Re: Approval of a three-year extension of approval of the Preliminary Plat of Fields Edge Addition

Re: Staff Review and Recommendation for the Resubmittal of the Preliminary Plat of Field's Edge Addition

FIELDS EDGE ADDITION

PRELIMINARY PLAT OF

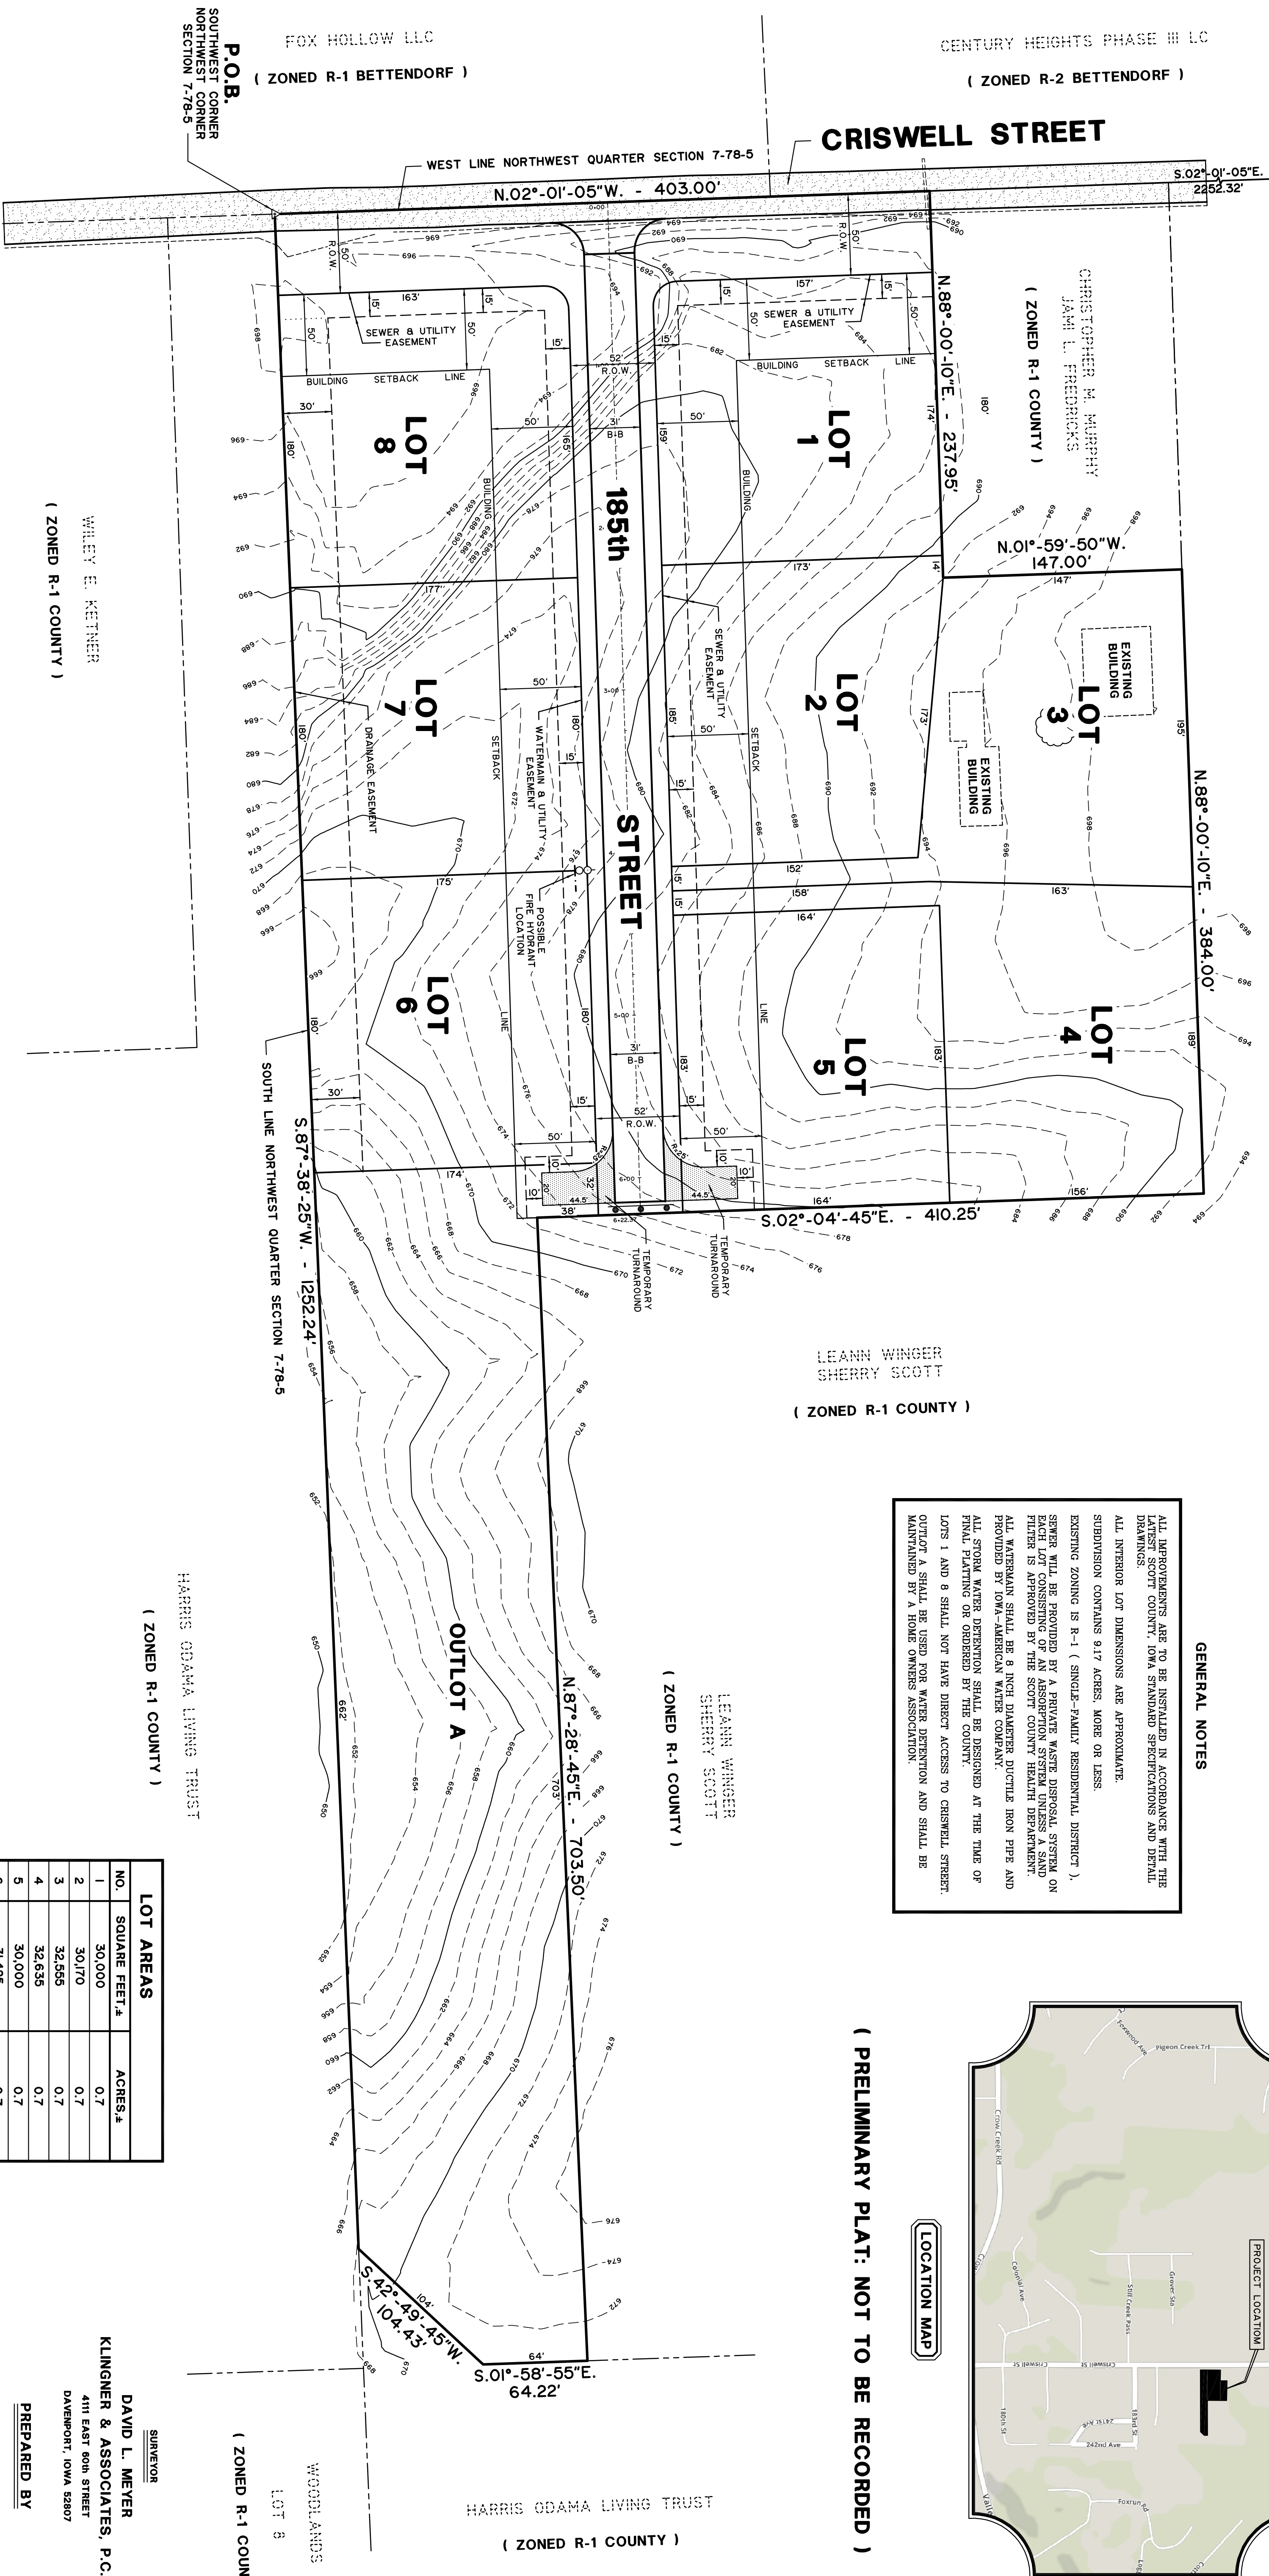
The County Engineer has reviewed the Stormwater Prevention Plan and the Erosion Control Plan and notes the Erosion Control Plan requires the contractor to inspect the erosion control devices on a weekly basis and after each rainfall. The County Engineer is requesting that copies of the contractor erosion reports be submitted to her office on a weekly basis.

The County Engineer also notes the temporary turnaround is not acceptable as shown on the Preliminary Plat. The hammerhead design is acceptable, but requires a hard surface. Gravel is not acceptable.

1. The private covenants include provisions for the ownership and maintenance of the proposed outlot;
2. The private covenants include provision for road maintenance of the private road;
3. The private covenants include provision for road maintenance of the shared private driveway between owners of lot 3 and lot 4;
4. The County Engineer review and approve all street construction plans following preliminary plat approval and prior to construction;
5. The applicant submit weekly erosion control performance reports to the County Engineer; and
6. The temporary hammerhead turnaround be constructed with an approved hard surface.
